# Spittal – Loch Buidhe – Beauly 400kV Overhead Line

Alignment Report on Consultation

January 2025

Figure 1: Potential and Alternative Alignment Options presented during consultation

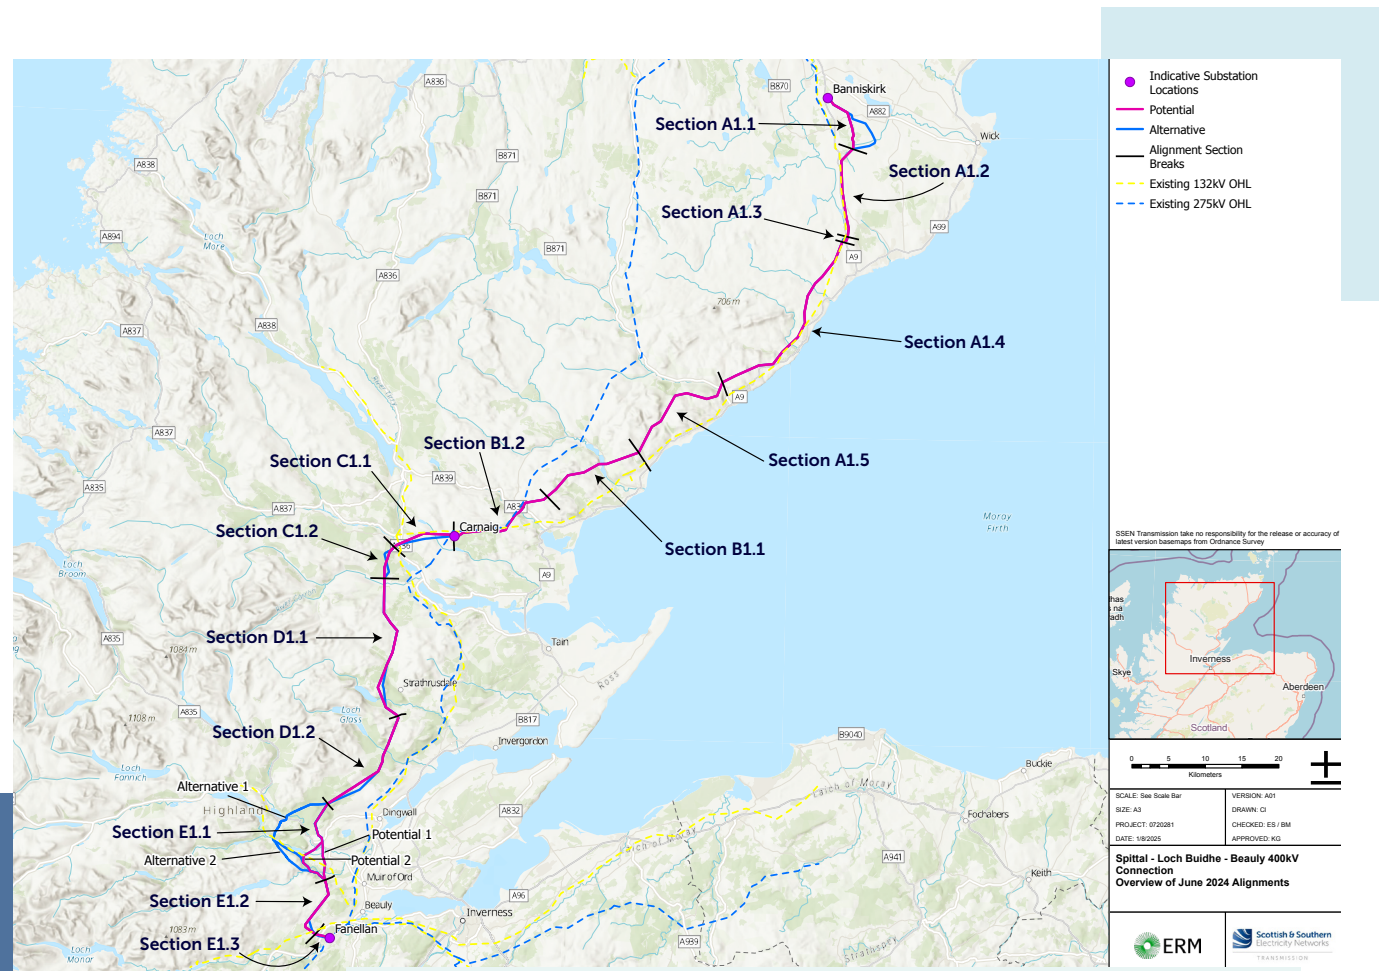
The consultation explained how we believe the Potential Alignment, shown in pink in Appendix B, offers the best balance of technical and environmental impact considerations identified through internal assessment and previous public and statutory consultation on route options. This was then subject to further consultation with stakeholders, where local and previously unknown considerations may confirm or alter the initial preference.

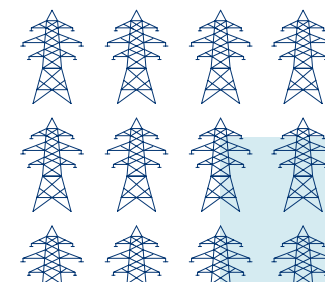
Comments received from the local community in relation to this Section focused on visualisations presented during the consultation, visual amenity, wildlife and habitat and cultural heritage.

HES advised that Potential Alignment A1.1 has a lower level of impact on the settings of local monuments and is unlikely to have significant adverse impacts on the setting of scheduled monuments when compared to Alternative Alignment A1.1.

NatureScot advised that they do not intend to provide further landscape and visual commentary at this stage but recognise that the Potential Alignment has addressed much of their previous feedback. NatureScot advised that compliance with standard mitigation measures during the construction work, including compliance with both project-wide and site-specific environmental management procedures (including SSEN Transmission’s General Environmental Management Plans (GEMPs), Species Protection Plans (SPPs) and a Construction Environment Management Plan (CEMP)) should ensure that the aquatic environment is protected against pollution, excessive sediment run off and accidents.

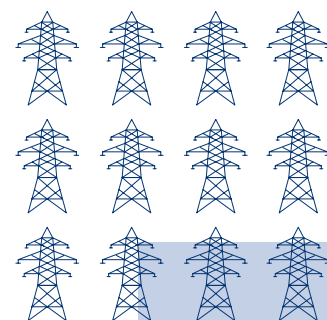
HES advised that Potential Alignment A1.5 has the potential to impact the several scheduled monuments, particularly along the River Helmsdale, SSEN Transmission is committed to working with HES to microsite the tower positions further through detailed design to minimise impacts where possible, given there are no other alternative options in this section.

NatureScotS advised that they do not intend to provide further landscape and visual commentary at this alignment stage but recognise that the Potential Alignment has addressed much of their previous feedback. NS advised that the compliance with the standard mitigation measures during the construction work, including compliance with both project wide and site-specific environmental management procedures, with reference to SSEN Transmission General Environmental Management Plans (GEMPs) and Species Protection Plans (SPPs) and a Construction Environment Management Plan (CEMP) should ensure that the aquatic environment is protected against pollution, excessive sediment run off and accidents.

Neither THC nor SEPA gave detailed commentary on alignment proposals, principles of development noted the constraints regarding to watercourse crossings, potential impacts on water features and flood plains.

MOD advised for structures to be charted on aviation maps and/or construction equipment details as per their requirements.

Figure 2: Overview of Proposed Alignments

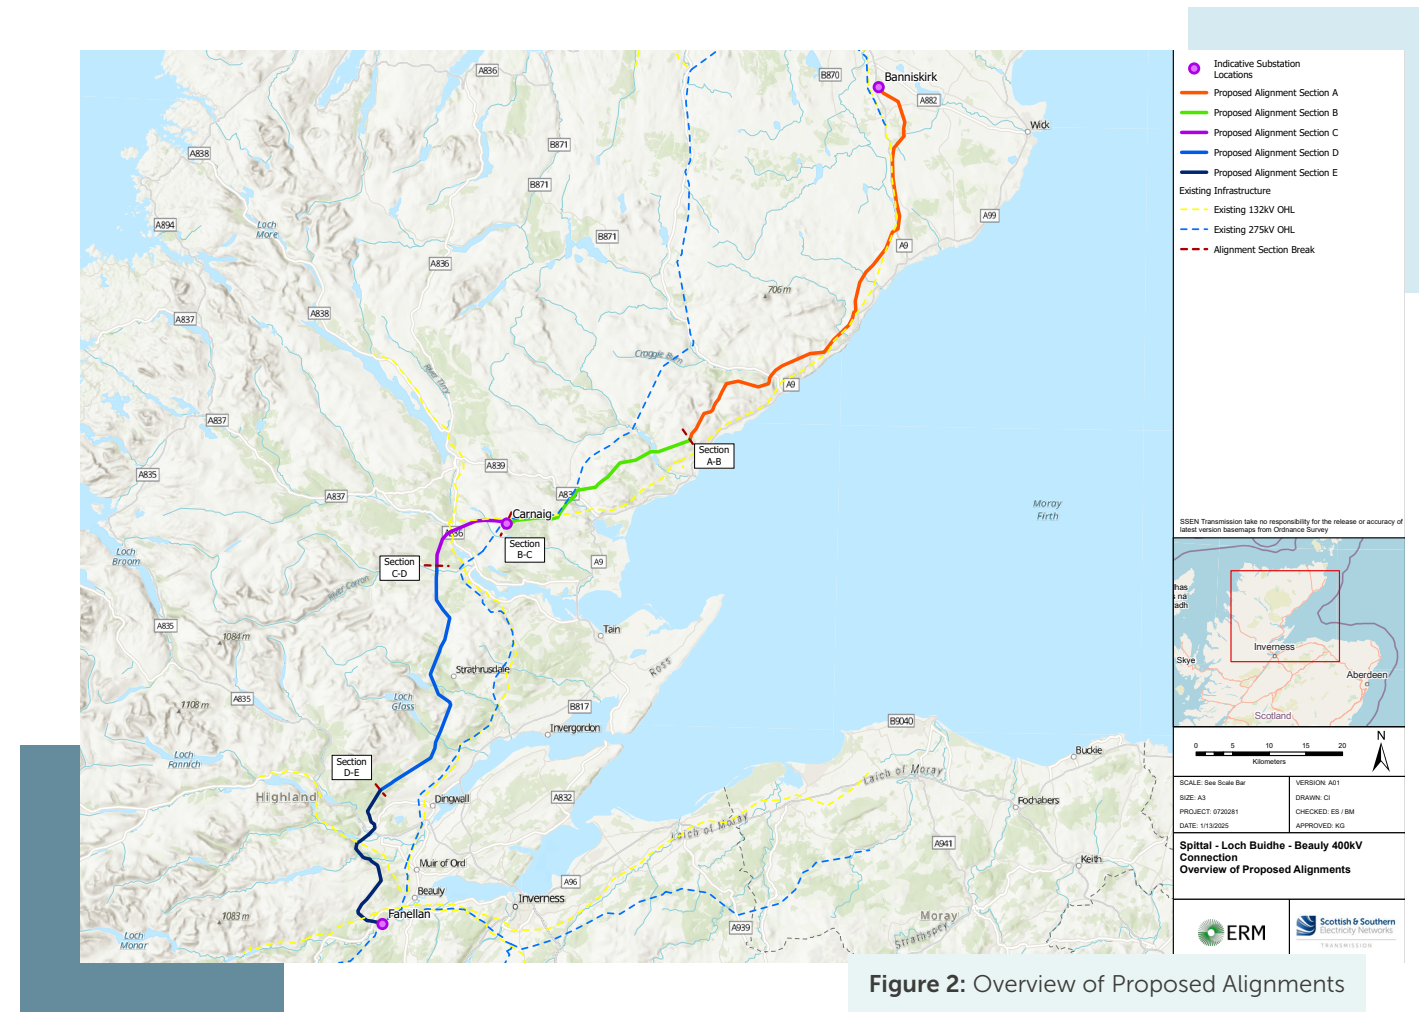
Potential Alignment E1.2 is preferred over Alternative Alignment E1.2 when considering both environmental and engineering constraints. Based on the feedback received, the Potential Alignment E1.2 was adjusted to avoid impacts on the schedule monuments northeast of the Breakachy Hill and to minimise impacts on watercourses south of Breakachy Hill.

Potential Alignment E1.3 is preferred over Alternative Alignment E1.3 when considering both environmental and engineering constraints.
